United States Patent and Trademark Office

APPLICATION NO.	F	ILING DATE	FIRST NAMED INVENTOR	ATTORNEY DOCKET NO.	CONFIRMATION NO.	
10/738,328		12/17/2003	Markus Hartmann	DT-6720	7915 ·	
30377	7590	02/23/2006		EXAM	EXAMINER	
DAVID TO	-	•	NGUYEN,	NGUYEN, PHONG H		
ABELMAN FRAYNE & SCHWAB 666 THIRD AVENUE				ART UNIT	PAPER NUMBER	
NEW YOR	NEW YORK, NY 10017-5621					
	•			DATE MAILED: 02/23/2006

DETAILED ACTION

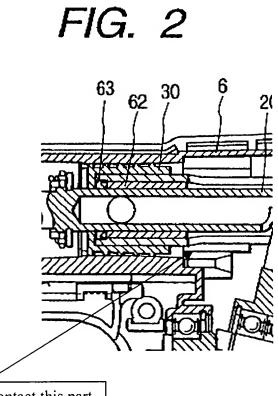
1992). In this case, the groove prevents the bearing sliding along the housing. Applicant further argues that adding a groove will not add any benefit. Providing a groove prevents the bearing contacting other parts in the saw assembly. Repeatedly contacting between the bearing and the other parts in the saw assembly may reduce the useful life of the saw. Providing a groove does not affect the swinging movement of the bolt 12 since it is made of a resilient material.

Bearing 30 may contact this part of the saw during its reciprocating movement.
